SUBJECT: Beaver Valley Power Station - Unit No. 2  
Docket No. 50-412  
Response to DSER Outstanding Issue 197

Attached is revised FSAR material in response to Outstanding Issue 197 of the Draft Safety Evaluation Report. This revision addresses those concerns raised by the reviewer in meetings on August 30, 1984, and September 26, 1984. This information will be incorporated in the FSAR upon acceptance by the reviewer.

PHYSICAL INDEPENDENCE OF ELECTRIC SYSTEMS (SEPTEMBER 1978)

FIGURE 8.3-31

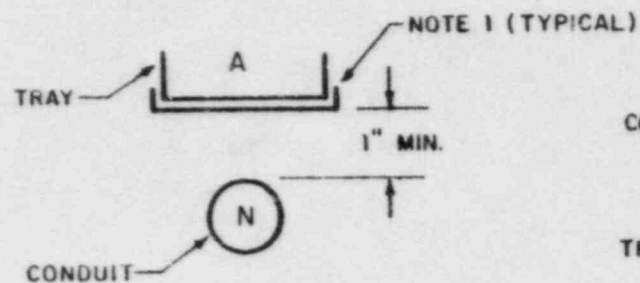
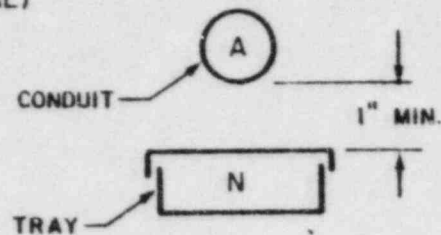
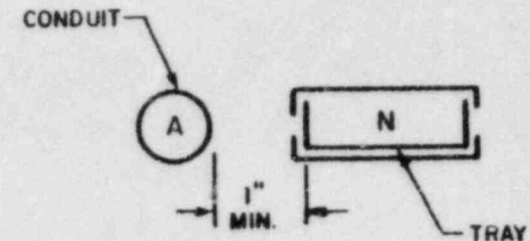
In the GPA, vertical separation between a Class 1E tray and a non-Class 1E conduit may be reduced to 1 in., where a tray cover on the bottom of the tray is installed as shown on Figure 8.3-31, Detail A.

In the GPA, vertical separation between a Class 1E conduit and a non-Class 1E tray may be reduced to 1 in., where a tray cover on top of the tray is installed as shown on Figure 8.3-31, Detail B.

In the GPA, horizontal separation between a Class 1E conduit and a non-Class 1E tray may be reduced to 1 in., where tray covers on the top and bottom of the tray are installed as shown on Figure 8.3-31, Detail C.

FIGURE 6.3-32

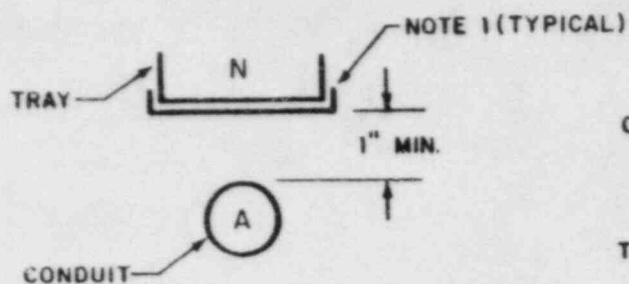
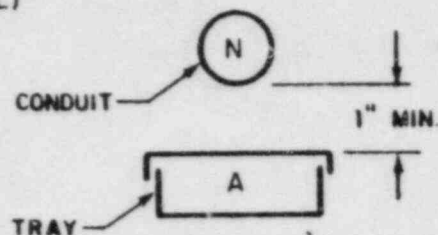
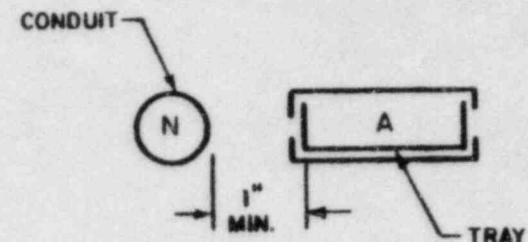
In the GPA, vertical separation between a non-Class 1E tray and a Class 1E conduit may be reduced to 1 in., where a tray cover on the bottom of the tray is installed as shown on Figure 8.3-32, Detail A.

In the GPA, vertical separation between a non-Class 1E conduit and a Class 1E tray may be reduced to 1 in., where a tray cover on the top of the tray is installed as shown on Figure 8.3-32, Detail B.

In the GPA, horizontal separation between a non-Class 1E conduit and Class 1E tray may be reduced to 1 in., where tray covers on the top and bottom of the tray are installed as shown on Figure 8.3-32, Detail C.

FIGURE 2.3-33

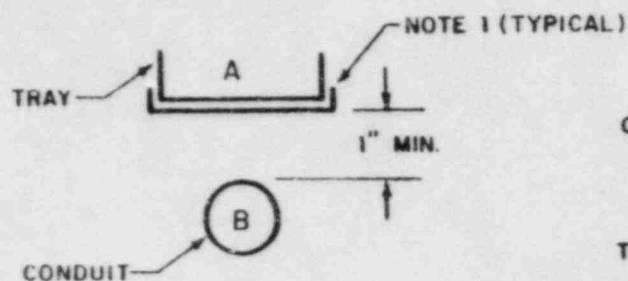
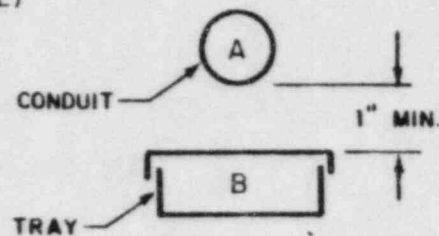
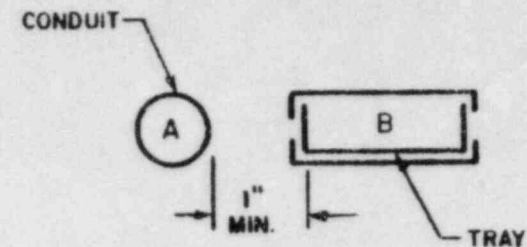
In the CSA, vertical separation between a Class 1E tray and a redundant Class 1E conduit may be reduced to 1 in., where a tray cover on the bottom of the tray is installed as shown on Figure 8.3-33, Detail A.

In the CSA, vertical separation between a Class 1E conduit and a redundant Class 1E tray may be reduced to 1 in., where a tray cover on the top of the tray is installed as shown on Figure 8.3-33, Detail B.

In the CSA, horizontal separation between a Class 1E conduit and a redundant Class 1E tray may be reduced to 1 in., where tray covers on the top and bottom of the tray are installed as shown on Figure 8.3-33, Detail C.

FIGURE 8.3-36  
GENERAL PLANT AREAS (GPA)  
ACCEPTABLE SEPARATION  
ARRANGEMENTS  
BEAVER VALLEY POWER STATION-UNIT 2  
FINAL SAFETY ANALYSIS REPORT

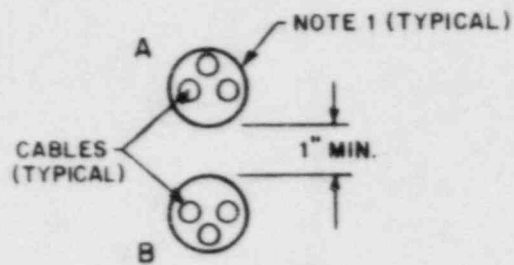
In the GPA, where cables are appropriately grouped together and are either installed in conduit or enclosed in a protective wrap, separation between Class 1E cables and redundant Class 1E cables, and between Class 1E cables and non-Class 1E cables may be reduced to 1 in. as shown on Figure 8.3-36, Details A, B, and C.

FIGURE 8.3-37  
CABLE SPREADING AREAS (CSA)  
ACCEPTABLE SEPARATION  
ARRANGEMENT  
BEAVER VALLEY POWER STATION-UNIT 2  
FINAL SAFETY ANALYSIS REPORT

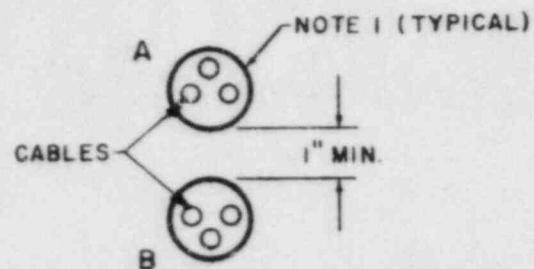
In the CSA, where cables are appropriately grouped together and are either installed in a conduit or enclosed in a protective wrap, separation between redundant Class 1E cables may be reduced to 1 in. as shown on Figure 8.3-37.

FIGURE 8.3-38

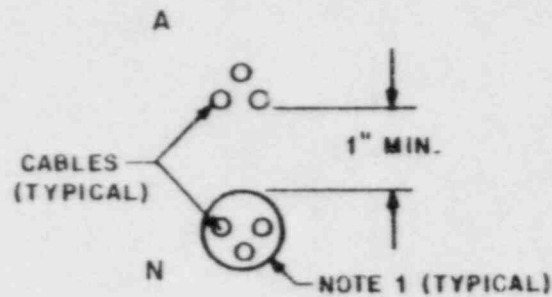
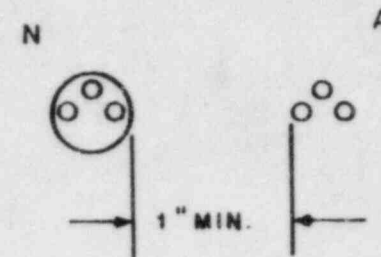
In the CSA, where cables are appropriately grouped together and the non-Class 1E group is installed in conduit or enclosed in a protective wrap, separation between the Class 1E cables and the non-Class 1E cables may be reduced to 1 in. as shown on Figure 8.3-38, Details A, B, and C.

FIGURE 8.3-39

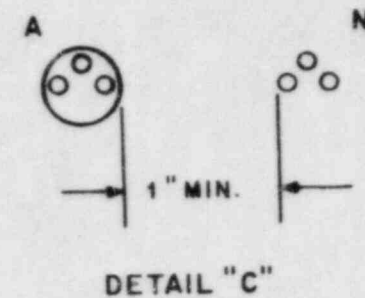
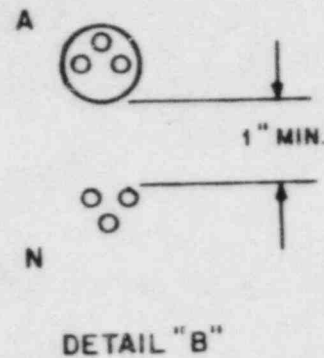
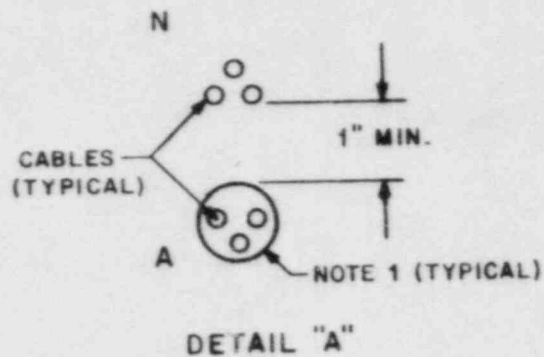
In the CSA, where cables are appropriately grouped together and the Class 1E group is installed in conduit or enclosed in a protective wrap, separation between the non-Class 1E cables and the Class 1E cables may be reduced to 1 in. as shown on Figure 8.3-39, Details A, B, and C.

FIGURE 8.3-40

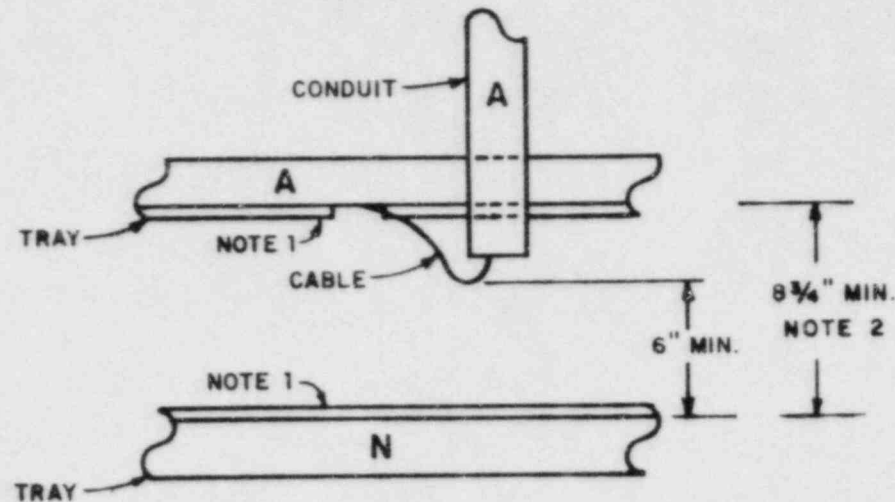
In non-hazardous general plant areas at locations of cable entry/exit from cable trays for Class 1E and non-Class 1E situations, a tray cover on the top of the lower tray with 6 in. minimum space as shown on Figures 8.3-40 and 41 provides the necessary separation.

In the GPA, where 8 3/4 in. minimum vertical spacing between Class 1E and non-Class 1E trays is maintained and tray covers are provided in accordance with Figure 8.3-16, Detail C, where a Class 1E cable enters the Class 1E tray, the separation between the Class 1E cable and the non-Class 1E tray may be reduced to 6 in. as shown on Figure 8.3-40.

FIGURE 8.3-41

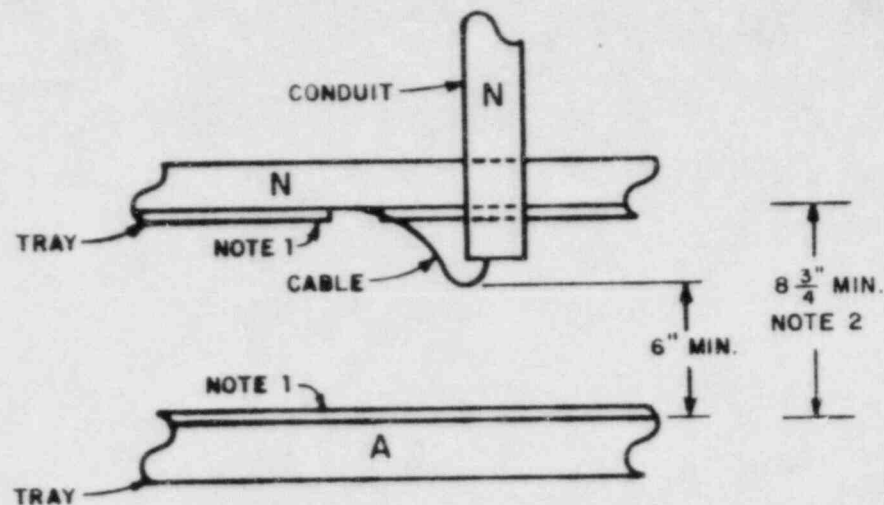
In the GPA, where 8 3/4 in. minimum vertical spacing between non-Class 1E and Class 1E trays is maintained and tray covers are provided in accordance with Figure 8.3-16, Detail B, where a non-Class 1E cable enters the non-Class 1E tray the separation between the non-Class 1E cable and the Class 1E tray may be reduced to 6 in. as shown on Figure 8.3-41.

**FIGURE 8.3-42**

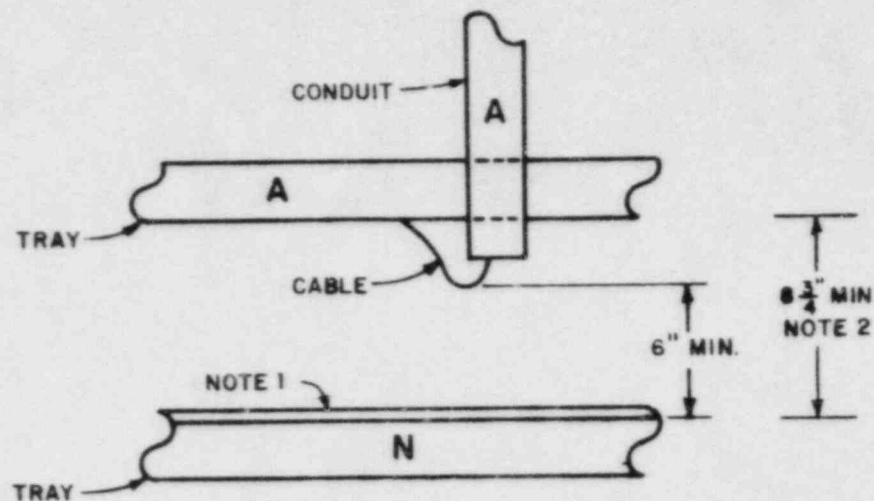
In the control room or cable spreading room at locations of cable entry/exit from cable trays for Class 1E and non-Class 1E situations, a tray cover on the top of the lower tray with 6 in. minimum space as shown on Figures 8.3-42 and 43 provides the necessary separation.

In the CSA, where 8 3/4 in. minimum vertical spacing between Class 1E and non-Class 1E trays is maintained and a tray cover is installed on the lower tray (non-Class 1E tray) in accordance with Figure 8.3-22, Detail A, where a Class 1E cable enters the Class 1E tray, the separation between the Class 1E cable and the non-Class 1E tray may be reduced to 6 in. as shown on Figure 8.3-42.

**FIGURE 8.3-43**

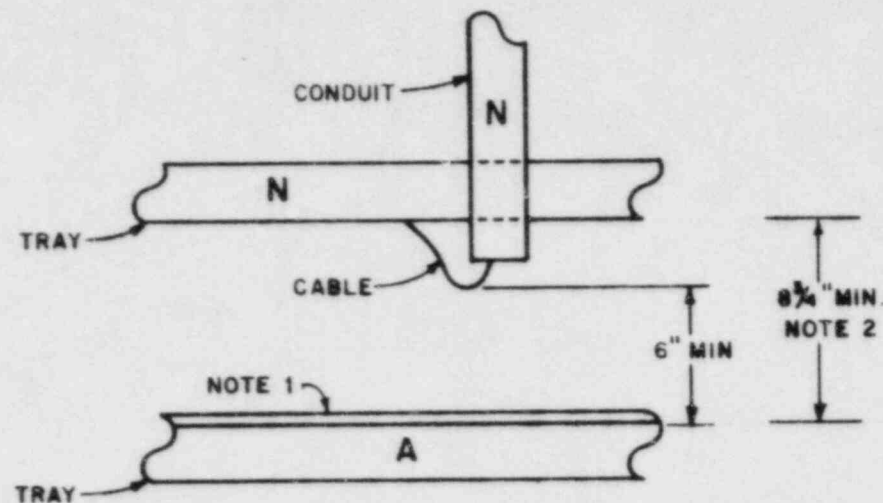
In the CSA, where 8 3/4 in. minimum vertical spacing between non-Class 1E and Class 1E trays is maintained and a tray cover is installed on the lower tray (Class 1E tray) in accordance with Figure 8.3-22, Detail C, where a non-Class 1E cable enters the non-Class 1E tray, the separation between the non-Class 1E cable and the Class 1E tray may be reduced to 6 in. as shown on Figure 8.3-43.

FIGURE 8.3-44  
GENERAL PLANT AREAS (GPA)  
ACCEPTABLE SEPARATION  
ARRANGEMENTS  
BEAVER VALLEY POWER STATION-UNIT 2  
FINAL SAFETY ANALYSIS REPORT

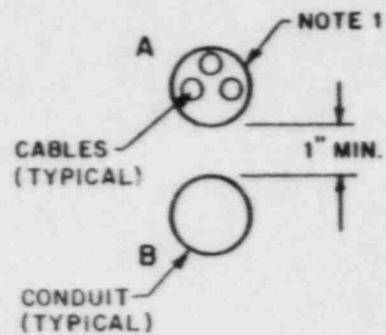
In the GPA, separation between Class 1E cables and a redundant Class 1E conduit may be reduced to 1 in., where the cables are enclosed in conduit or a protective wrap as shown on Figure 8.3-44, Detail A.

In the GPA, separation between Class 1E cables and a non-Class 1E conduit may be reduced to 1 in., where the cables are enclosed in conduit or a protective wrap as shown on Figure 8.3-44, Detail B.

In the GPA, separation between non-Class 1E cables and a Class 1E conduit may be reduced to 1 in., where the cables are enclosed in conduit or a protective wrap as shown on Figure 8.3-44, Detail C.

FIGURE 8.3-45  
CABLE SPREADING AREAS (CSA)  
ACCEPTABLE SEPARATION  
ARRANGEMENT  
BEAVER VALLEY POWER STATION-UNIT 2  
FINAL SAFETY ANALYSIS REPORT

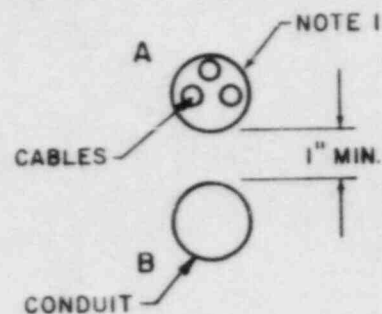
In the CSA, separation between Class 1E cables and a redundant Class 1E conduit may be reduced to 1 in., where the cables are enclosed in conduit or a protective wrap as shown on Figure 8.3-45.

FIGURE 8.3-46

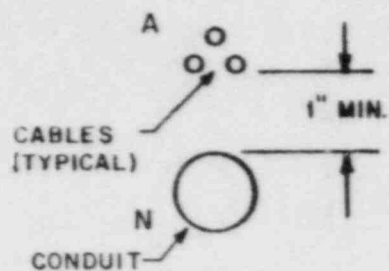
In the CSA, separation between Class 1E cables and a non-Class 1E conduit may be reduced to 1 in. as shown on Figure 8.3-46, Details A, B, and C.

FIGURE 8.3-47

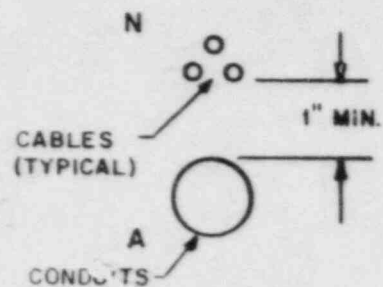
In the CSA, separation between non-Class 1E cables and a Class 1E conduit may be reduced to 1 in. as shown on Figure 8.3-47, Details A, B, and C.

FIGURE 8.3-48  
 RAISED HIGH HAT TRAY COVER  
 BEAVER VALLEY POWER STATION-UNIT 2  
 FINAL SAFETY ANALYSIS REPORT

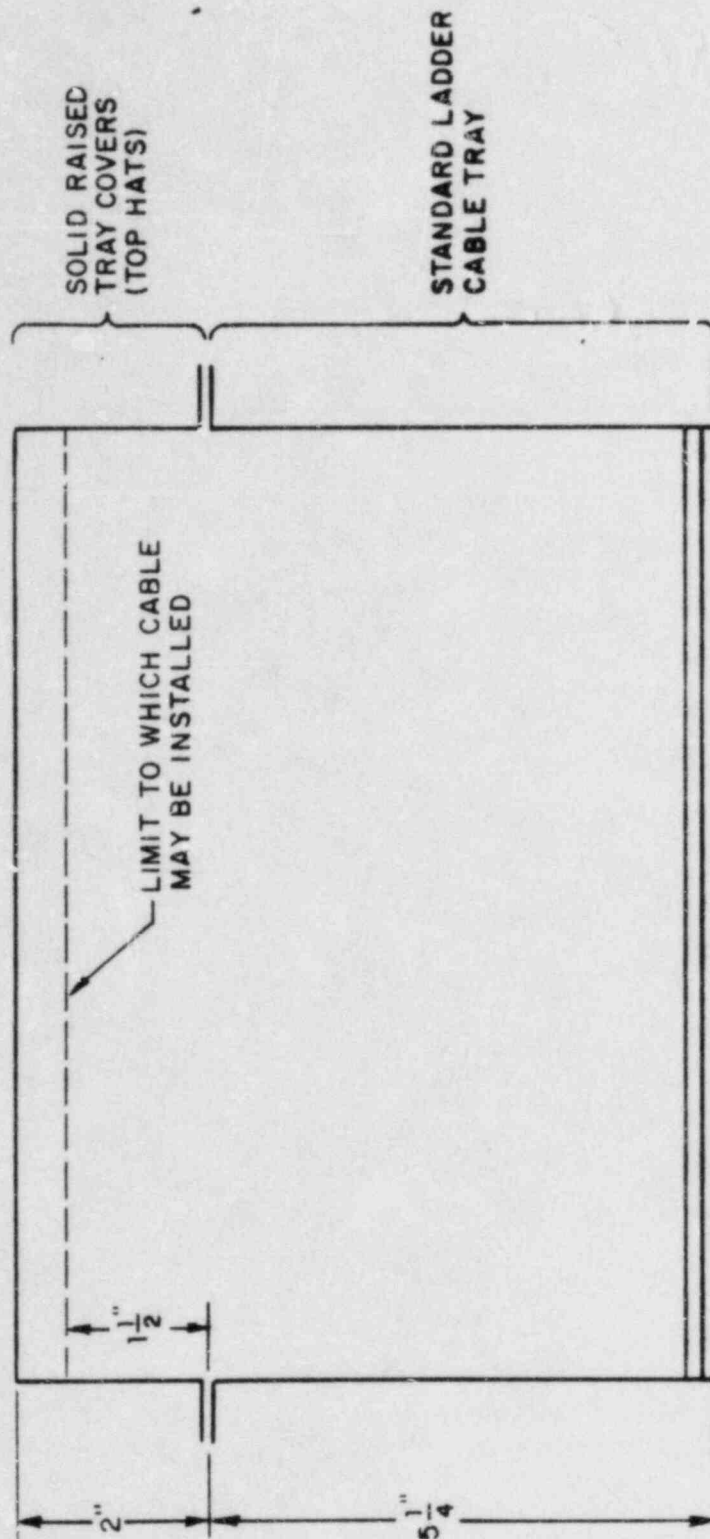
Cable trays for control and instrumentation cables may be filled above the side rails where the overfill has been limited to a maximum of 1 1/2 in. above the top of the side rail and where solid high-hat covers with a 2 in. raised flat center section are used to enclose the top of the cable tray as shown on Figure 8.3-48.
